Ecology Action Comments on Proposed Title 24 2016 Code Language**Background**

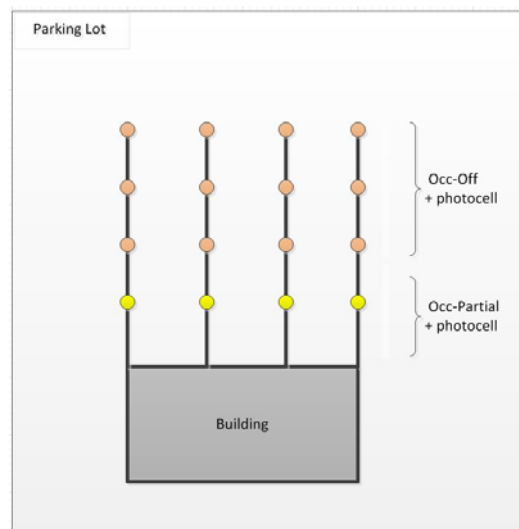
The two main problems with the current time clock requirements: 1) time clocks are cost-prohibitive on small jobs (minimum \$1,000+), and 2) existing circuit layout will often result in a time clock never being used even if it were installed. Ecology Action brought up this problem in the May 15, 2014 exterior lighting stakeholder webinar, and it was suggested to “just change the circuiting”. Unfortunately the problem can’t typically be fixed with circuiting changes in most existing building exterior projects due to having to tear up pavement in a parking lot, etc. See the example below:

In the figure above, the parking lot has 16 existing fixtures on four circuits. The customer runs two shifts, and the parking lot lights are on all night but only the closest row of parking spots are typically used. The sensible retrofit would be to have only the four closest fixtures controlled by Partial-On Occupancy Sensors plus Photocells, and the remaining fixtures with Occupancy-Off Sensors plus Photocells. An added time clock control is cost-prohibitive in this scenario, and even if installed, would never be used. Attempting to achieve the sensible retrofit through circuiting changes is also not feasible due to the cost of tearing up the parking lot. We believe the addition of the numeric thresholds and related language we are proposing in blue above will alleviate this issue.

To remedy this, we believe the Code needs to include numeric thresholds in addition to the existing percentage thresholds for small exterior lighting jobs. These proposed provisions would apply to existing buildings with photocells only as shown in the Table below. For jobs with photocells and occupancy-off controls on $\leq 50\%$ of fixtures the time clock requirement would go away. In the table below, black text is per 2013 Code and our proposed text is in blue (see Exterior Details).
